Product Change Notice (PCN)

Subject: Wafer-fabrication and chip-assembly factories addition for RL78/G23 QFN and LQFP package products

Publication Date: 6/30/2025

Differences

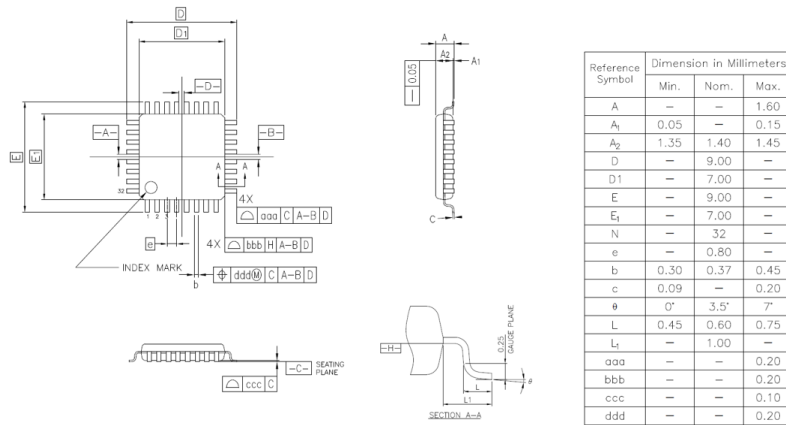
Items		Additional factory	Current
Wafer process		PSMC	Kawashiri
Assembly		Greatek	BJ, KL
Sort		KYEC	BJ, KL
Package	Outline	Slight differences (see below)	
Lead frame	Material	No difference	
	Inner lead shape	Shape difference (see below)	
Die mount	Material	Ag epoxy paste D *	Ag epoxy paste A *
Bonding wire	Material	No difference: Cu (Pd coating)	
Mold resin	Material	Epoxy resin D * (halogen-free)	Epoxy resin A * (halogen-free)
Plating	Material	No difference	
Marking	Font	Font type difference (see below)	
	Digit number	Slight difference (see below)	
Packing	Tray / T&R	No difference	
Storage conditions	after opening	No difference

48pin_LQFP
7mm×7mm 0.5mm pitch 48pin LFQFP Package Outline (Greatek)

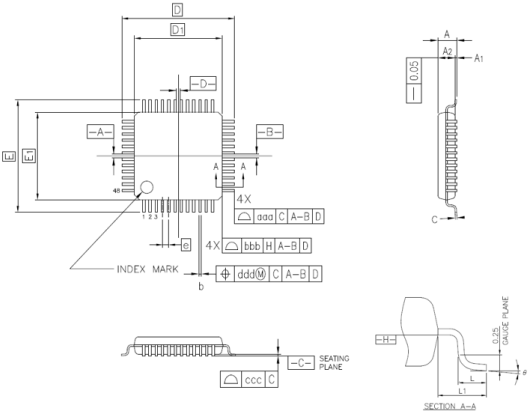
Comparison: 7mm×7mm 0.5mm pitch 48pin LFQFP package

Greatek Symbol	7x7mm 48pin LQFP PLQP0048KL-A			BJ Symbol	7x7mm 48pin LQFP PLQP0048KB-B		
	Dimension in Millimeters				Dimension in Millimeters		
	Min	Nom	Max		Min	Nom	Max
A	-	-	1.60	A	-	-	1.70
A1	0.05	-	0.15	A1	0.05	-	0.15
A2	1.35	1.40	1.45	A2	-	1.40	-
D	-	9.00	-	HD	8.80	9.00	9.20
D1	-	7.00	-	D	6.90	7.00	7.10
E	-	9.00	-	HE	8.80	9.00	9.20
E1	-	7.00	-	E	6.90	7.00	7.10
N	-	48	-	-	-	-	-
e	-	0.50	-	e	-	0.50	-
b	0.17	0.22	0.27	bp	0.17	0.20	0.27
c	0.09	-	0.20	c	0.09	-	0.20
θ	0°	3.5°	7°	θ	0°	3.5°	8°
L	0.45	0.60	0.75	Lp	0.45	0.60	0.75
L1	-	1.00	-	L1	-	1.00	-
aaa	-	-	0.20	-	-	-	-
bbb	-	-	0.20	-	-	-	-
ccc	-	-	0.08	y	-	-	0.08
ddd	-	-	0.08	x	-	-	0.08

64pin_LQFP
10mm×10mm 0.5mm pitch 64pin LFQFP Package Outline (Greatek)

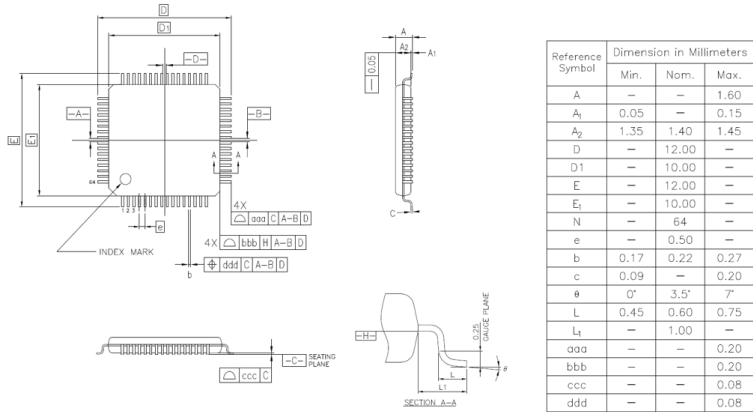
Comparison: 10mm×10mm 0.5mm pitch 64pin LFQFP package

Greatek Symbol	10x10mm 64pin LQFP PLQP0064KL-A			BJ Symbol	10x10mm 64pin LQFP PLQP0064KB-C		
	Dimension in Millimeters				Dimension in Millimeters		
	Min	Nom	Max		Min	Nom	Max
A	-	-	1.60	A	-	-	1.70
A1	0.05	-	0.15	A1	0.05	-	0.15
A2	1.35	1.40	1.45	A2	-	1.40	-
D	-	12.00	-	HD	11.80	12.00	12.20
D1	-	10.00	-	D	9.90	10.00	10.10
E	-	12.00	-	HE	11.80	12.00	12.20
E1	-	10.00	-	E	9.90	10.00	10.10
N	-	64	-	-	-	-	-
e	-	0.50	-	e	-	0.50	-
b	0.17	0.22	0.27	bp	0.15	0.20	0.27
c	0.09	-	0.20	c	0.09	-	0.20
θ	0°	3.5°	7°	θ	0°	3.5°	8°
L	0.45	0.60	0.75	Lp	0.45	0.60	0.75
L1	-	1.00	-	L1	-	1.000	-
aaa	-	-	0.20	-	-	-	-
bbb	-	-	0.20	-	-	-	-
ccc	-	-	0.08	y	-	-	0.08
ddd	-	-	0.08	x	-	-	0.08

80pin_LQFP
12mm×12mm 0.5mm pitch 80pin LFQFP Package Outline (Greatek)

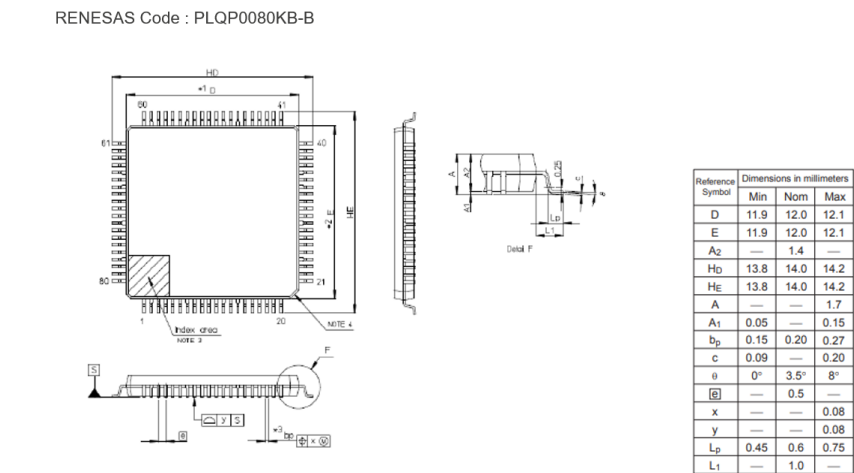
Comparison: 12mm×12mm 0.5mm pitch 80pin LFQFP package

Greatek Symbol	12x12mm 80pin LQFP PLQP0080KJ-A			BJ Symbol	12x12mm 80pin LQFP PLQP0080KB-B		
	Dimension in Millimeters				Dimension in Millimeters		
	Min	Nom	Max		Min	Nom	Max
A	-	-	1.60	A	-	-	1.70
A1	0.05	-	0.15	A1	0.05	-	0.15
A2	1.35	1.40	1.45	A2	-	1.40	-
D	-	14.00	-	HD	13.80	14.00	14.20
D1	-	12.00	-	D	11.90	12.00	12.10
E	-	14.00	-	HE	13.80	14.00	14.20
E1	-	12.00	-	E	11.90	12.00	12.10
N	-	80	-	-	-	-	-
e	-	0.50	-	e	-	0.50	-
b	0.17	0.22	0.27	bp	0.15	0.20	0.27
c	0.09	-	0.20	c	0.09	-	0.20
θ	0°	3.5°	7°	θ	0°	3.5°	8°
L	0.45	0.60	0.75	Lp	0.45	0.60	0.75
L1	-	1.00	-	L1	-	1.000	-
aaa	-	-	0.20	-	-	-	-
bbb	-	-	0.20	-	-	-	-
ccc	-	-	0.08	y	-	-	0.08
ddd	-	-	0.08	x	-	-	0.08
